Access Audit Site Report

Goliad State Park
108 Park Road 6
Goliad, TX 77963
Accessibility Evaluation
Inspection Date: 06/16/2022
Inspectors: Tanya Scheibe

**TEXAS PARKS AND WILDLIFE DEPARTMENT
GOLIAD STATE PARK AND STATE HISTORIC SITE**

**AMERICANS WITH DISABILITIES ACT COMPLIANCE INITIATIVE
PROGRAM AND POLICY REPORT**

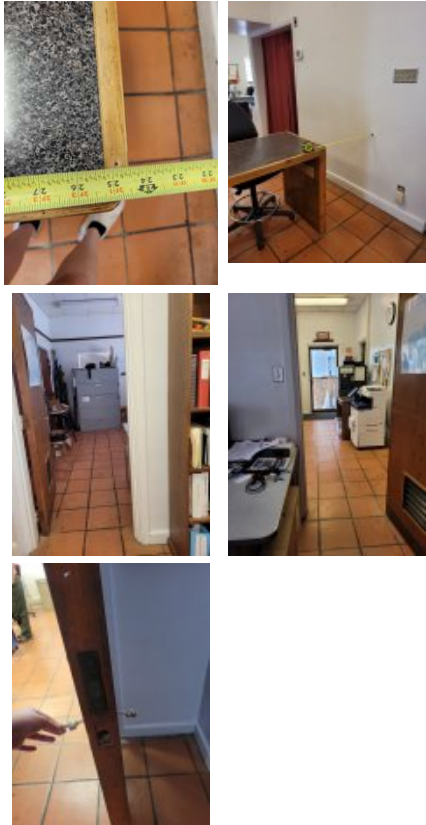
Finding Number	Area Description	Lat/Long	Finding	As Built	Recommendation	Citation	Photos	Figure
12	Headquarters (HQ) : HQ - Parking and Exterior Accessible Route	[28.6564817 , -97.387099 4]	The access aisle is not a minimum 5 feet wide. A car accessible parking stall's access aisle must be a minimum of 5 feet wide measured from centerline to centerline. Where the access aisle is not adjacent to another parking space or access aisle, measurements shall be permitted to include the full width of the line defining the access aisle.	HQ parking - Access aisle (AA) is 56.25"	Repaint access aisles to be 5' each.	2015 ABAAS Section: 502.3.1 2012 TAS Section: 502.3.1 2010 ADAS Section: 502.3.1		
13	Headquarters (HQ) : HQ - Parking and Exterior Accessible Route	[28.6564923 , -97.387080 6]	Element meets all standards and requirements	HQ parking meets scoping requirements - 10 standard, 1 accessible	None	2010 ADAS Section: N/A

14	Headquarters (HQ) : HQ - Public Spaces	[28.6565535 , -97.387212]	The floor mat or carpet pile height is too high. Carpet or carpet tile shall be securely attached and shall have a firm cushion, pad, or backing or no cushion or pad. Carpet or carpet tile shall have a level loop, textured loop, level cut pile, or level cut/uncut pile texture. Pile height shall be 1/2 inch maximum. Exposed edges of carpet shall be fastened to floor surfaces and shall have trim on the entire length of the exposed edge.	3 of 3 floor mats are not secured	Secure rug to prevent trip hazard.	2015 ABAAS Section: 302.2 2012 TAS Section: 302.2 2010 ADAS Section: 302.2

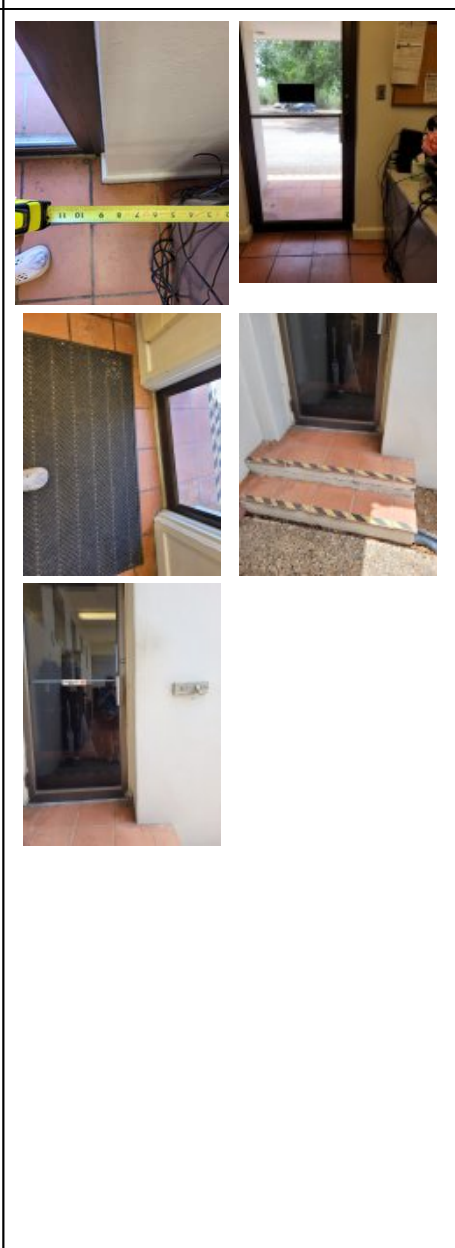
Finding Number	Area Description	Lat/Long	Finding	As Built	Recommendation	Citation	Photos	Figure
18	Headquarters (HQ) : HQ - Public Spaces	[28.6565465 , -97.387230 8]	The operable part is positioned too high for either a side or front approach. Where a clear floor or ground space allows a parallel approach to an element and the side reach is unobstructed, the high side reach shall be 48 inches maximum and the low side reach shall be 15 inches minimum above the finish floor or ground. Where a forward reach is unobstructed, the high forward reach shall be 48 inches maximum and the low forward reach shall be 15 inches minimum above the finish floor or ground.	Donation box at 51" above the finished floor (AFF)	Remount operable parts to be in reach range of 15" min to 48" max.	2015 ABAAS Section: 308.1 2012 TAS Section: 308.1 2010 ADAS Section: 308.1		
19	Headquarters (HQ) : HQ - Public Spaces	[28.6565229 , -97.387246 9]	Minimum maneuvering clearances at doors and gates shall comply with 404.2.4. Maneuvering clearances shall extend the full width of the doorway and the required latch side or hinge side clearance. The threshold has a gap greater than 1/2 inch wide. Exterior doors are recommended to be maintained at 8.5 lbf as a smart practice. Force is to be measured at the operating hardware or 30 inches from the hinges, whichever is greater.	Entry door - 15# push, clearance on push side reduced by desk, 1.75" gap	For all doors along the public circulation route, provide required maneuvering clearance on push and pull side of doors. For all doors along the public circulation route, fill gaps at door entries to max .5". For all doors along the public circulation route, inspect, adjust, and maintain 8.5 lbf to open exterior doors as a smart practice.	2010 ADAS Section: 404.2.3, 404.2.7, 404.2.4, 404.2.11, 404.2.11 Exception

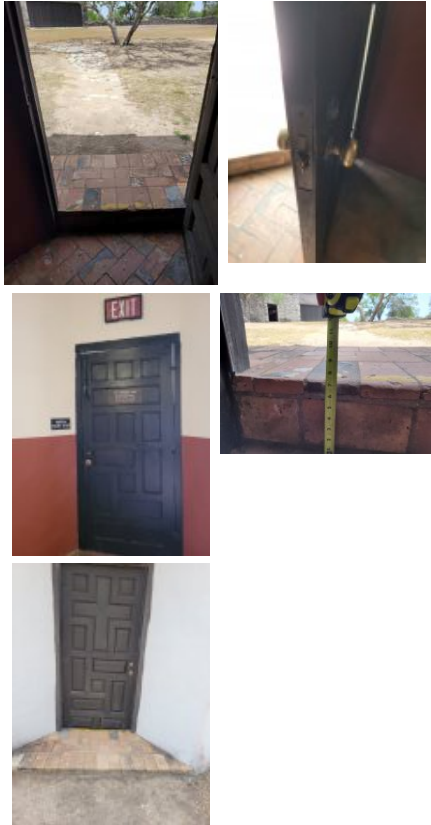
Finding Number	Area Description	Lat/Long	Finding	As Built	Recommendation	Citation	Photos	Figure
44	Mission Espiritu Santo: Mission Espiritu Santo - Public Spaces	[28.6573479 , -97.3868003]	The operable part is positioned too high for either a side or front approach. Where a clear floor or ground space allows a parallel approach to an element and the side reach is unobstructed, the high side reach shall be 48 inches maximum and the low side reach shall be 15 inches minimum above the finish floor or ground. Where a forward reach is unobstructed, the high forward reach shall be 48 inches maximum and the low forward reach shall be 15 inches minimum above the finish floor or ground.	Donation box at 48.25" above the finished floor (AFF)	Remount operable parts to be in reach range of 15" min to 48" max. In the alternative, leave as is citing construction tolerance.	2015 ABAAS Section: 308.1 2012 TAS Section: 308.1 2010 ADAS Section: 308.1

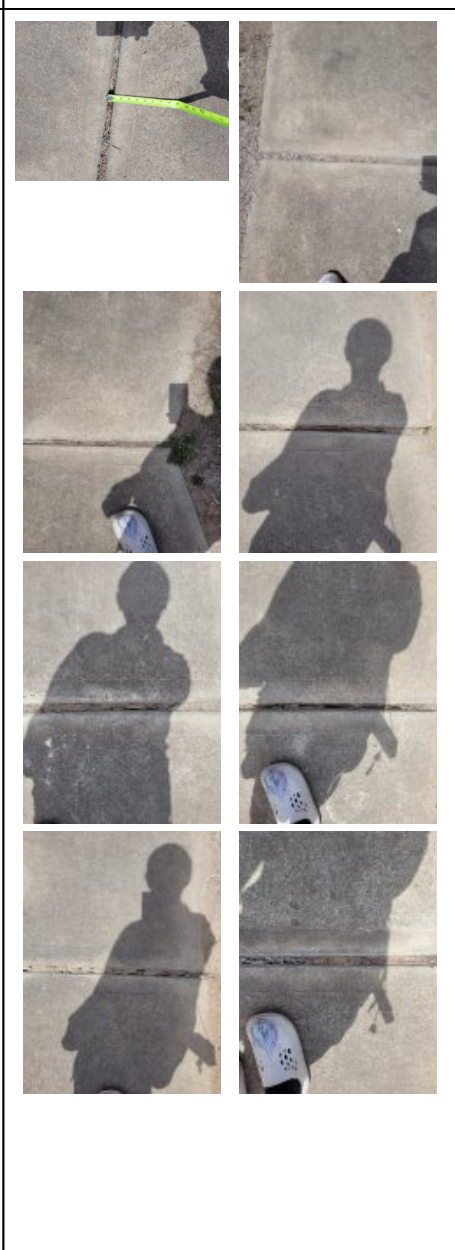
Finding Number	Area Description	Lat/Long	Finding	As Built	Recommendation	Citation	Photos	Figure
50	Mission Espiritu Santo: Mission Espiritu Santo - Employee Spaces	[28.6572008 , -97.386785 5]	Spaces and elements within employee work areas shall only be required to comply with 206.2.8, 207.1, and 215.3 and shall be designed and constructed so that individuals with disabilities can approach, enter, and exit the employee work area. Employee work areas, or portions of employee work areas, other than raised courtroom stations, that are less than 300 square feet (28 m2) and elevated 7 inches (180 mm) or more above the finish floor or ground where the elevation is essential to the function of the space shall not be required to comply with these requirements or to be on an accessible route.	Assumed employees open doors each day - excessive force required	Inspect, adjust, and maintain 8.5 lbf to open exterior doors as a smart practice.	2015 ABAAS Section: F203.9 2012 TAS Section: 203.9 2010 ADAS Section: 203.9

51	Mission Espiritu Santo: Mission Museum	[28.6573326 , -97.386876 7]	Door openings shall provide a clear width of 32 inches (815 mm) minimum. Clear openings of doorways with swinging doors shall be measured between the face of the door and the stop, with the door open 90 degrees. Openings more than 24 inches (610 mm) deep shall provide a clear opening of 36 inches (915 mm) minimum. There shall be no projections into the required clear opening width lower than 34 inches (865 mm) above the finish floor or ground. Projections into the clear opening width between 34 inches (865 mm) and 80 inches (2030 mm) above the finish floor or ground shall not exceed 4 inches (100 mm). Exterior doors are recommended to be maintained at 8.5 lbf as a smart practice. Force is to be measured at the operating hardware or 30 inches from the hinges, whichever is greater. Hand-activated door opening hardware, handles, pulls, latches, locks, and other operating devices on accessible doors shall have a shape that is easy to grasp with one hand and does not require tight grasping, tight pinching or twisting of the wrist to operate. Hardware shall be 34 inches minimum and 48 inches maximum above the finish floor or ground.	mission museum door - 14# push, 27.5" width, pinch required for pull side hardware	For all doors along the public circulation route, replace doors with doors having 80" overhead clearance and 32" clear width. For all doors along the public circulation route, inspect, adjust, and maintain 8.5 lbf to open exterior doors as a smart practice. For all doors along the public circulation route, replace hardware with lever hardware or hardware operable without a tight pinch or grasp.	2010 ADAS Section: 404.2.3, 404.2.7, 404.2.4, 404.2.11, 404.2.11 Exception

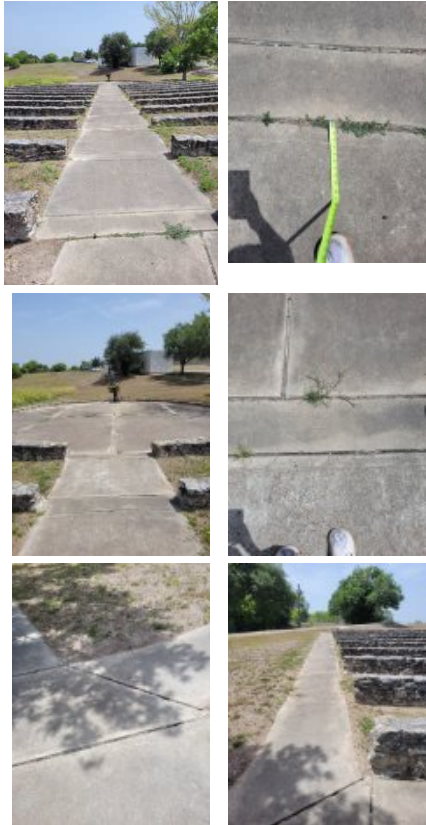
Finding Number	Area Description	Lat/Long	Finding	As Built	Recommendation	Citation	Photos	Figure
58	Mission Espiritu Santo: Mission Museum	[28.657382, -97.386833 8]	The walkway contains abrupt vertical edges and/or variations over a 1/4 inch. 1/4 inch is the maximum vertical rise. Changes in level between 1/4 inch and 1/2 inch must be beveled at 1:2 or less. Changes in level greater than 1/2 inch must be by way of a ramp.	rear entry - 8" change in elevation (CIL)	Ramp CIL at entry.	2012 TAS Section: 303.2, 303.3 2010 ADAS Section: 303.2, 303.3		
59	Mission Espiritu Santo: Mission Museum	[28.657695, -97.386769 4]	The running slope of walking surfaces shall not be steeper than 1:20.	Ramp on back side of workshop - 8.1% at top and 6.8% at bottom	Correct running slope along the AR to max 5%, or treat as a ramp and add handrails on both sides.	2015 ABAAS Section: 403.3 2012 TAS Section: 403.3 2010 ADAS Section: 403.3

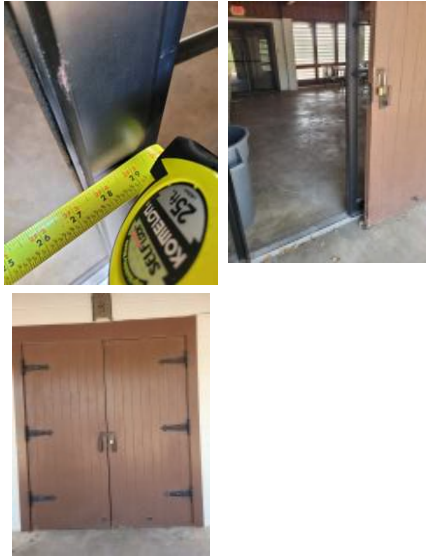
Finding Number	Area Description	Lat/Long	Finding	As Built	Recommendation	Citation	Photos	Figure
97	Group Hall : Group Hall - Parking and Exterior Accessible Route	[28.6552472 , -97.383600 4]	The accessible route of travel contains cross slopes greater than 2%. Cross slopes shall not exceed one unit vertical in 48 units horizontal (2-percent slope).	Path between men's restroom and women's at Group Hall along parking - cross slopes of 5%, 3%, 3% - needs repaving	Correct or repair cross slope along AR to max 2.08%.	2015 ABAAS Section: 403.3 2012 TAS Section: 403.3 2010 ADAS Section: 403.3		
98	Group Hall : Group Hall - Parking and Exterior Accessible Route	[28.6553226 , -97.383624 6]	The walkway contains abrupt vertical edges and/or variations over a 1/4 inch. 1/4 inch is the maximum vertical rise. Changes in level between 1/4 inch and 1/2 inch must be beveled at 1:2 or less. Changes in level greater than 1/2 inch must be by way of a ramp.	To men's and Group Hall entry - 2" CIL	Repair, bevel or ramp CIL along AR.	2012 TAS Section: 303.2, 303.3 2010 ADAS Section: 303.2, 303.3

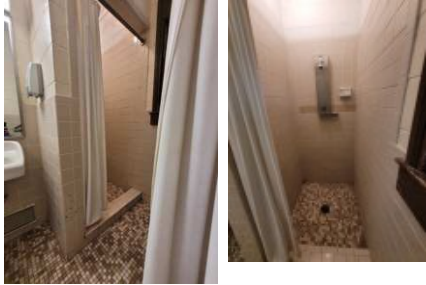
Finding Number	Area Description	Lat/Long	Finding	As Built	Recommendation	Citation	Photos	Figure
102	Group Hall : Group Hall - Public Spaces	[28.655379, -97.383642]	Knee and toe space has not been provided at the sink. Kitchen sinks must be provided with a clear floor space positioned for a forward approach including knee and toe clearance.	Group Hall Kitchen - cabinet under sink	Remove base cabinet.	2015 ABAAS Section: 606.2, 804.4 2012 TAS Section: 606.2, 804.4 2010 ADAS Section: 606.2, 804.4		
103	Group Hall : Group Hall - Public Spaces	[28.6553932 , -97.383652 7]	An item or items project more than 4 inches into the circulation path. Wall-mounted objects that have leading edges between 27 inches and 80 inches from the floor must not project more than 4 inches into the circulation path. Protruding objects that extend to the floor or within 27 inches of the floor are cane detectable and are therefore not hazardous. Where it is necessary or desirable to have objects protrude from the wall, a manner of cane detection must be provided.	Group Hall Kitchen - fire extinguisher projects 5"	Relocate protruding objects or place cane detectable warning or bollard at foot of item.	2015 ABAAS Section: 307.2 2012 TAS Section: 307.2 2010 ADAS Section: 307.2

104	Group Hall : Group Hall - Public Spaces	[28.6553908 , -97.383671 5]	The operable part is positioned too high for either a side or front approach. Where a clear floor or ground space allows a parallel approach to an element and the side reach is unobstructed, the high side reach shall be 48 inches maximum and the low side reach shall be 15 inches minimum above the finish floor or ground. Where a forward reach is unobstructed, the high forward reach shall be 48 inches maximum and the low forward reach shall be 15 inches minimum above the finish floor or ground.	Group Hall Kitchen - light switch at 59" above the finished floor (AFF)	Remount operable parts to be in reach range of 15" min to 48" max.	2015 ABAAS Section: 308.1 2012 TAS Section: 308.1 2010 ADAS Section: 308.1

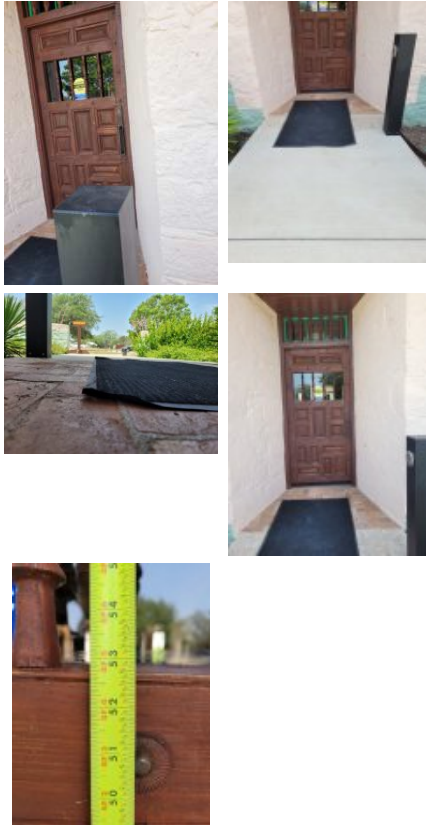
Finding Number	Area Description	Lat/Long	Finding	As Built	Recommendation	Citation	Photos	Figure
120	Group Hall : Group Hall - Men's Restroom	[28.6553849 , -97.383654 1]	There are no accessible bathing or shower facilities. Where facilities for bathing are provided for the public, clients or employees, including showers or bathtubs, at least one shower or bathtub and support facilities such as lockers, and not less than 1 percent of all facilities, shall be accessible.	Lacks accessible shower	Create an accessible shower in locker/bathing room.	2015 ABAAS Section: F213.3.6 2012 TAS Section: 213.3.6 2010 ADAS Section: 213.3.6

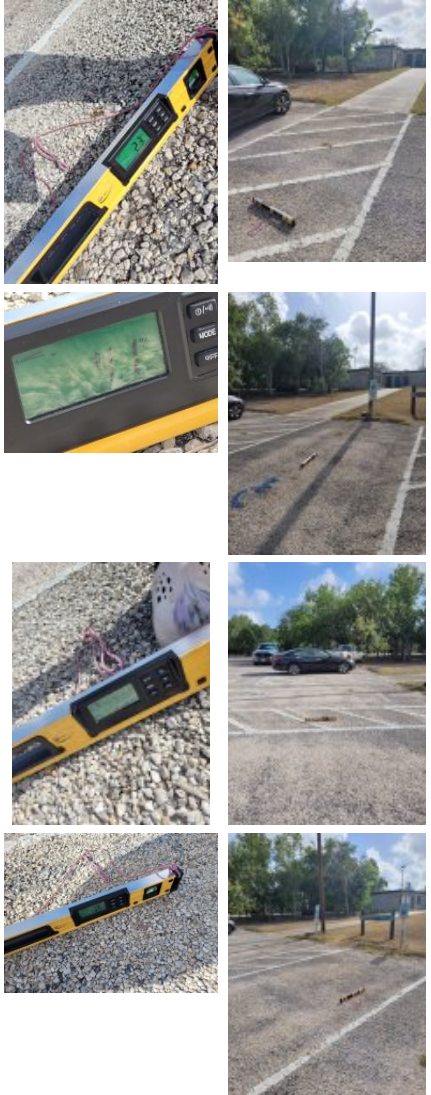
Finding Number	Area Description	Lat/Long	Finding	As Built	Recommendation	Citation	Photos	Figure
139	El Camino Real de los Tejas Visitors Center: Visitor Center - Employee Space	[28.6613184 , -97.3849616]	Spaces and elements within employee work areas shall only be required to comply with 206.2.8, 207.1, and 215.3 and shall be designed and constructed so that individuals with disabilities can approach, enter, and exit the employee work area. Employee work areas, or portions of employee work areas, other than raised courtroom stations, that are less than 300 square feet (28 m2) and elevated 7 inches (180 mm) or more above the finish floor or ground where the elevation is essential to the function of the space shall not be required to comply with these requirements or to be on an accessible route.	Doors within (are propped opened by staff) - knob, maneuvering clearance to patio room is 2"	For employee spaces, relocate storage, furniture, and other obstacles at doorways to provide approach, enter and exit at the employee space. Provide required maneuvering clearance on push and pull side of doors. Replace hardware with lever hardware or hardware operable without a tight pinch or grasp.	2015 ABAAS Section: F203.9 2012 TAS Section: 203.9 2010 ADAS Section: 203.9

140	El Camino Real de los Tejas Visitors Center: Visitor Center - Men's Restroom	[28.6612996 , -97.3848758]	Element meets all standards and requirements	Visitors Center men's restroom door complies	None	2010 ADAS Section: N/A		
141	El Camino Real de los Tejas Visitors Center: Visitor Center - Men's Restroom	[28.6613078 , -97.3848704]	The mirror is mounted too high. Mirrors must have the bottom edge of the reflecting surface a maximum of 40 inches above the floor if above a sink or counter. Mirrors not located above lavatories or countertops shall be installed with the bottom edge of the reflecting surface 35 inches maximum above the finish floor or ground.	Bottom edge of mirror at 40.5" above the finished floor (AFF)	Lower mirror so bottom reflective surface is max 40" AFF and 74" at the top.	2015 ABAAS Section: 603.3 2012 TAS Section: 603.3 2010 ADAS Section: 603.3

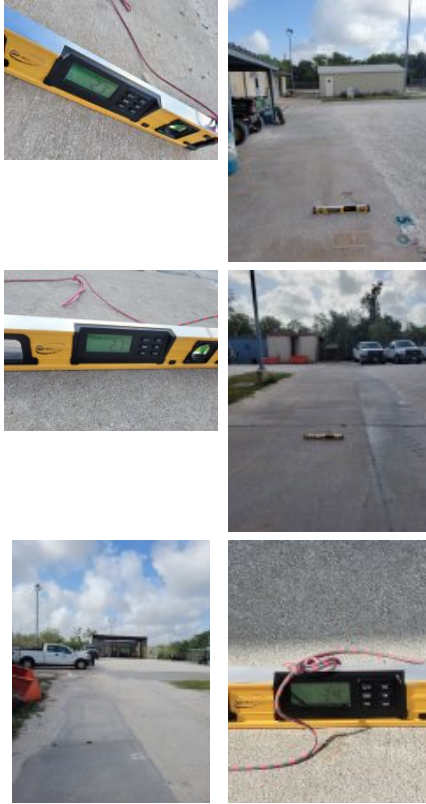
Finding Number	Area Description	Lat/Long	Finding	As Built	Recommendation	Citation	Photos	Figure
154	Employee Spaces: Maintenance	[28.656377, -97.383894 1]	The building entrance is not located on an accessible route. When a building, or portion of a building, is required to be accessible, an accessible route of travel shall be provided to all portions of the building, to accessible building entrances and between the building and the public way. All walks, halls, corridors, aisles, skywalks, tunnels, and other spaces that are part of an accessible route must comply. An accessible route of travel must not pass through kitchens, storage rooms, restrooms, closets or other spaces used for similar purposes. At least one accessible route within the boundary of the site must be provided from public transportation stops, accessible parking and accessible passenger loading zones and public streets or sidewalks to the accessible building entrance they serve. The accessible route shall, to the maximum extent feasible, coincide with the route for the general public. At least one accessible route shall connect accessible buildings, facilities, elements and spaces that are on the same site. At least one accessible route shall connect accessible building or facility entrances with all accessible spaces and elements.	Maintenance - lacks route (AR) to tractor shed due to surface	Create AR with crushed and compacted stone or similar outdoor material from parking or sidewalk to building entrance.	2015 ABAAS Section: F206.2.1 2012 TAS Section: 206.2.1 2010 ADAS Section: 206.2.1

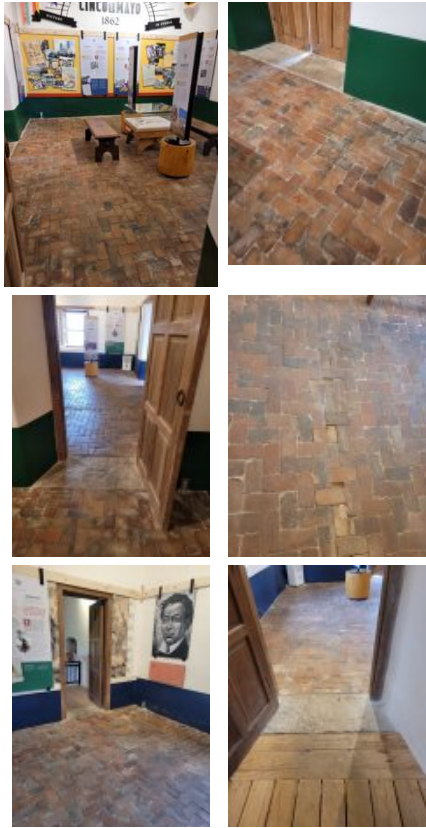
Finding Number	Area Description	Lat/Long	Finding	As Built	Recommendation	Citation	Photos	Figure
165	Employee Spaces: Maintenance Restroom	[28.6564664 , -97.383937]	The bench is not deep enough or long enough or is missing. Benches shall be provided having seats that are 42 inches long minimum and 20 inches deep minimum and 24 inches deep maximum. The bench shall provide for back support or shall be affixed to a wall. Back support shall be 42 inches (1065 mm) long minimum and shall extend from a point 2 inches (51 mm) maximum above the seat surface to a point 18 inches (455 mm) minimum above the seat surface. Back support shall be 2½ inches (64 mm) maximum from the rear edge of the seat measured horizontally. The top of the bench seat surface shall be 17 inches (430 mm) minimum and 19 inches (485 mm) maximum above the finish floor or ground. Clear floor or ground space complying with 305 shall be provided and shall be positioned at the end of the bench seat and parallel to the short axis of the bench	Lacks changing bench	Acquire and install bench in dressing area having a seat depth of 20" to 24" deep, 42" long, affixed to the wall or having a back and mounted 17" to 19" AFF and provide required clear floor space on the short axis of the bench.	2012 TAS Section: 903.4, 903.2, 903.3, 903.5 2010 ADAS Section: 903.4, 903.2, 903.3, 903.5

166	Employee Spaces: Maintenance Restroom	[28.6565123 , -97.383934 3]	The operable parts of controls are not located correctly. In standard roll-in type shower compartments, the controls, faucets, and shower spray unit shall be located above the grab bar, but no higher than 48 inches (1220 mm) above the shower floor. Where a seat is provided, the controls, faucets, and shower spray unit shall be installed on the back wall adjacent to the seat wall and shall be located 27 inches (685 mm) maximum from the seat wall. Advisory 608.5.2 Standard Roll-In Type Shower Compartments. In standard roll-in type showers without seats, the shower head and operable parts can be located on any of the three walls of the shower without adversely affecting accessibility.	40" between seat and controls	Remount shower controls to the correct location in the roll in shower.	2015 ABAAS Section: 608.5.2 2012 TAS Section: 608.5.2 2010 ADAS Section: 608.5.2

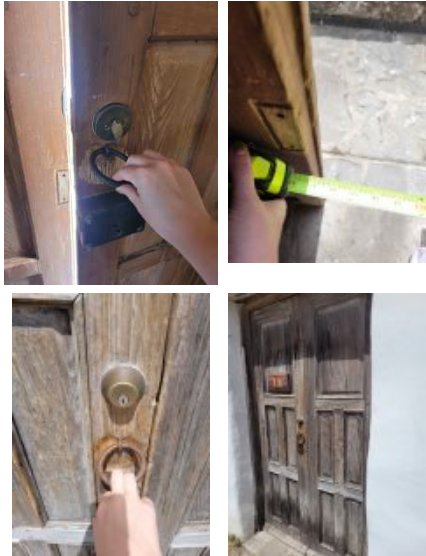
Finding Number	Area Description	Lat/Long	Finding	As Built	Recommendation	Citation	Photos	Figure
167	Employee Spaces: Maintenance Restroom	[28.6565017 , -97.3839384]	The restroom sign does not comply with one or more applicable requirements for the location, height, and properties of the sign.	Maintenance restroom lacks signage	Acquire and mount signage, including Braille, raised lettering and access symbol mounted on wall, latch side of door, 48" to baseline of lowest character and 60" to baseline of highest character.	2015 ABAAS Section: F216.2, 703.1, 703.2, 703.5, 703.6 2012 TAS Section: 216.2, 703.1, 703.2, 703.5, 703.6 2010 ADAS Section: 216.2, 703.1, 703.2, 703.5, 703.6		
168	Employee Spaces: Maintenance Restroom	[28.6564947 , -97.383937]	The toilet paper is not installed within the compliant range in front of the toilet. Toilet paper dispensers shall be 7 inches minimum and 9 inches maximum in front of the water closet measured to the centerline of the dispenser. The outlet of the dispenser shall be 15 inches minimum and 48 inches maximum above the finish floor and shall not be located behind grab bars. Dispensers shall not be of a type that controls delivery or that does not allow continuous paper flow. There shall be a clearance of 1 1/2 inches minimum below the grab bar.	TP dispenser too close to front edge of the toilet	Remount toilet paper dispenser max 7" to 9" from front of toilet, 15" to 48" AFF and min 12" above or 1.5" below grab bar.	2015 ABAAS Section: 604.7 2012 TAS Section: 604.7 2010 ADAS Section: 604.7

169	Employee Spaces: Maintenance Restroom	[28.6565041 , -97.383937]	Openings in floor or ground surfaces shall not allow passage of a sphere more than 1/2 inch (13 mm) diameter except as allowed in 407.4.3, 409.4.3, 410.4, 810.5.3 and 810.10. Elongated openings shall be placed so that the long dimension is perpendicular to the dominant direction of travel.	5" gap at floor drain	Fill and maintain gaps to max .5".	2015 ABAAS Section: 302.3 2012 TAS Section: 302.3 2010 ADAS Section: 302.3

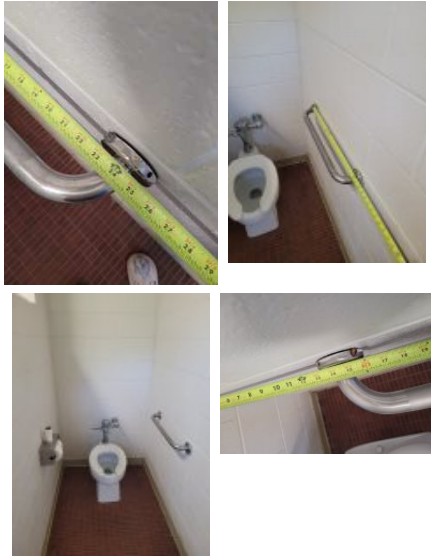
Finding Number	Area Description	Lat/Long	Finding	As Built	Recommendation	Citation	Photos	Figure
201	Camping and Shelters: Women's Restroom - Longhorn Tent Camping	[28.6508293 , -97.3858897]	The side grab bars are not in the correct location. Grab bars on the side wall must be installed so that the end closest to the rear wall is maximum 12" from the rear wall. The end furthest from the rear wall must be mounted minimum 54" from the rear wall.	Both bars extend 39" from rear wall	Remount side grab bar to max 12" from the rear wall at the close end and min 54" on the far end, and 33" to 36" AFF.	2015 ABAAS Section: 604.5.1 2012 TAS Section: 604.5.1 2010 ADAS Section: 604.5.1

Finding Number	Area Description	Lat/Long	Finding	As Built	Recommendation	Citation	Photos	Figure
202	Camping and Shelters: Women's Restroom - Longhorn Tent Camping	[28.6508281 , -97.385895]	The grab bar height and/or spacing fails. Grab bars must be mounted between 33" and 36" to the top of the gripping surface. There must be 1.5" of clearance between the grab bar and the wall. There must be a minimum of 1.5" of clearance below and minimum 12" above the grab bar to any dispenser or other obstruction.	Both grab bars are mounted 3" from wall and are 32" above the finished floor (AFF)	Replace grab bars in accessible stall to with ones having a gap of 1.5" between bar and wall. See previous findings for mounting.	2015 ABAAS Section: 609.3, 609.4 2012 TAS Section: 609.4, 609.3 2010 ADAS Section: 609.3, 609.4	 	
203	Camping and Shelters: Women's Restroom - Longhorn Tent Camping	[28.6508281 , -97.385893 7]	The toilet paper is not installed within the compliant range in front of the toilet. Toilet paper dispensers shall be 7 inches minimum and 9 inches maximum in front of the water closet measured to the centerline of the dispenser. The outlet of the dispenser shall be 15 inches minimum and 48 inches maximum above the finish floor and shall not be located behind grab bars. Dispensers shall not be of a type that controls delivery or that does not allow continuous paper flow. There shall be a clearance of 1 1/2 inches minimum below the grab bar.	TP dispenser is too close to the front edge of the toilet	Remount toilet paper dispenser max 7" to 9" from front of toilet, 15" to 48" AFF and min 12" above or 1.5" below grab bar.	2015 ABAAS Section: 604.7 2012 TAS Section: 604.7 2010 ADAS Section: 604.7
